Great North Road Solar and Biodiversity Park

DraftFinal Statement of Common Ground with National Highways

Document Reference – EN010162/APP/8.4C4D

APPENDIX 1: CONSTRUCTION TRAFFIC FLOW DIAGRAMS

Project:
AADT CONSTRUCTION TRAFFIC FLOWS ON A1
WORST CASE (100% Route North AND 100% Route South)

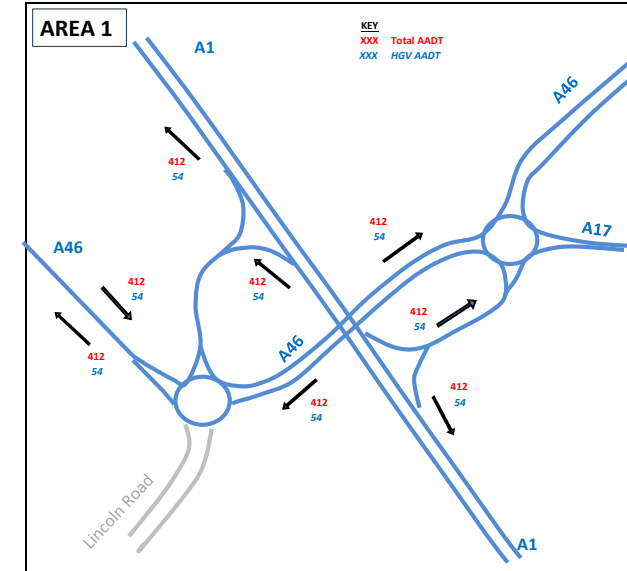
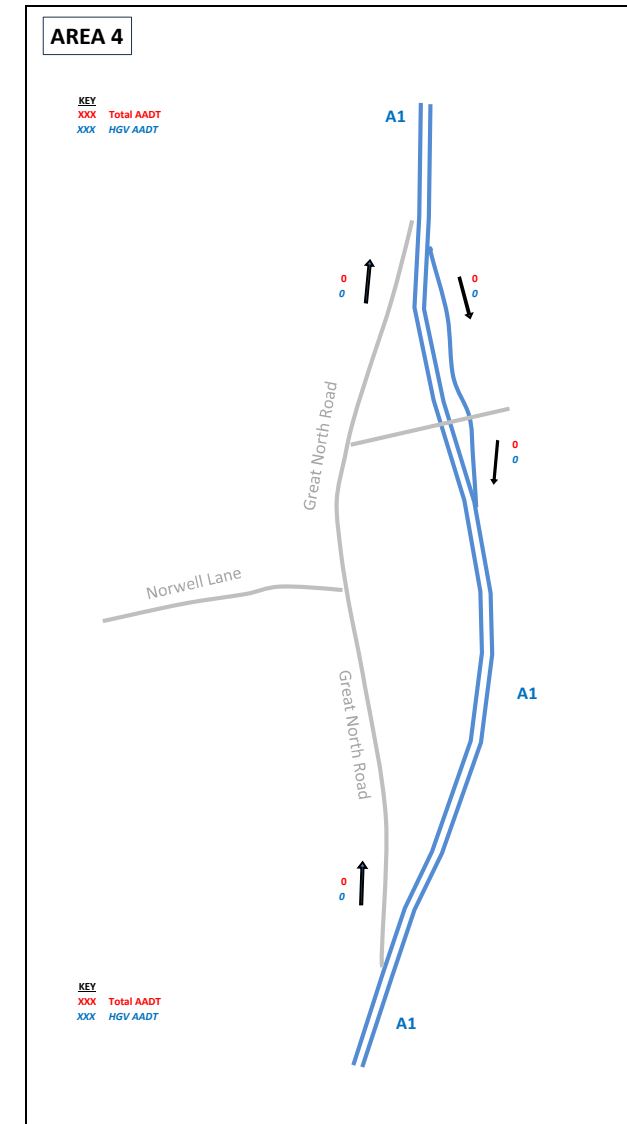
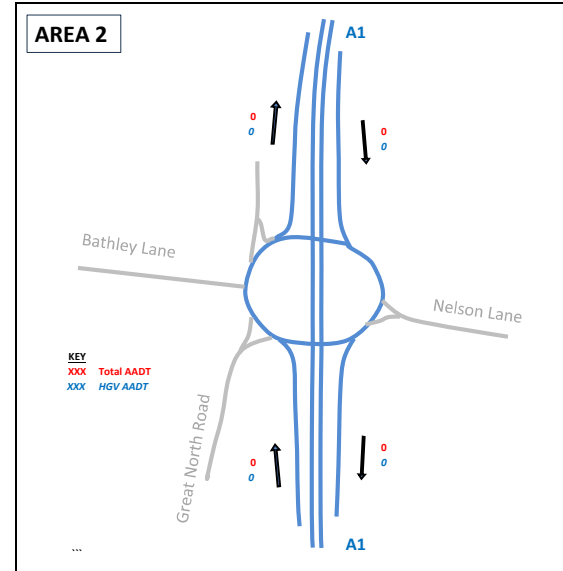
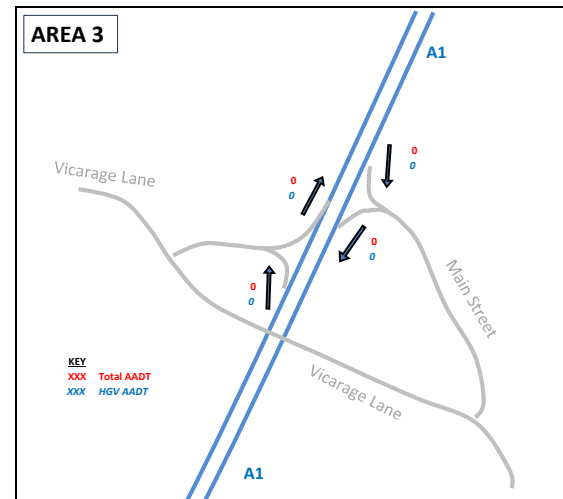
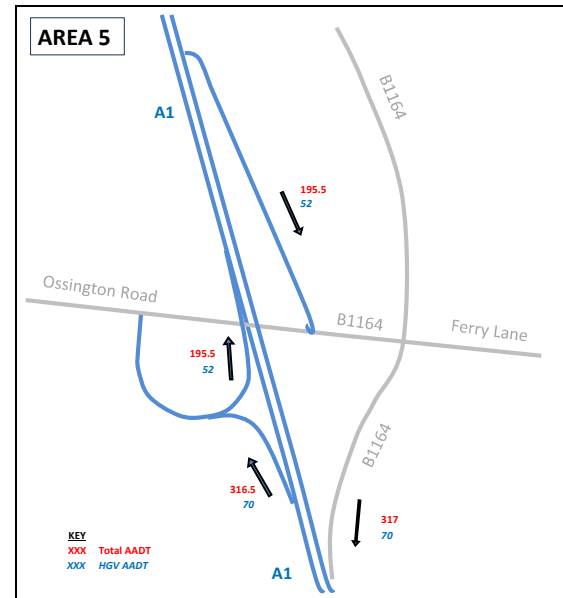
Month																									1	2	3	4	5	6	7	8	9	10	11	12	13	14	15	16	17	18	19	20	21	Trips on A1	0	12	20	26	6	10	10	11	11	11	7	4	1	16	28	36	8	12	13	13	13	
	Month																																																																									
	1	2	3	4	5	6	7	8	9	10	11	12	13	14	15	16	17	18	19	20	21																																																					
Trips on A1	0	12	20	26	6	10	10	11	11	11	7	4	1	16	28	36	8	12	13	13	13																																																					
2.1.5	WR	Trip Distribution	NH has reviewed the further information provided by the Applicant and is now content that the trip distribution is agreed. The additional information provided in the	Traffic flow diagrams for the junctions on the A1 were provided at Deadline 1. The flows presented are the AADT construction traffic flows on the A1, assuming a scenario whereby all traffic routes to/from the north and also, all traffic routes to/from the south. These diagrams	Agreed

revised ES Chapter alongside the traffic flow diagrams provided at Deadline 1 provides clarity on the development proposals impact on the A1 and are deemed acceptable by NH.	will show the traffic flows currently presented in Appendix 1 of this SoCG.
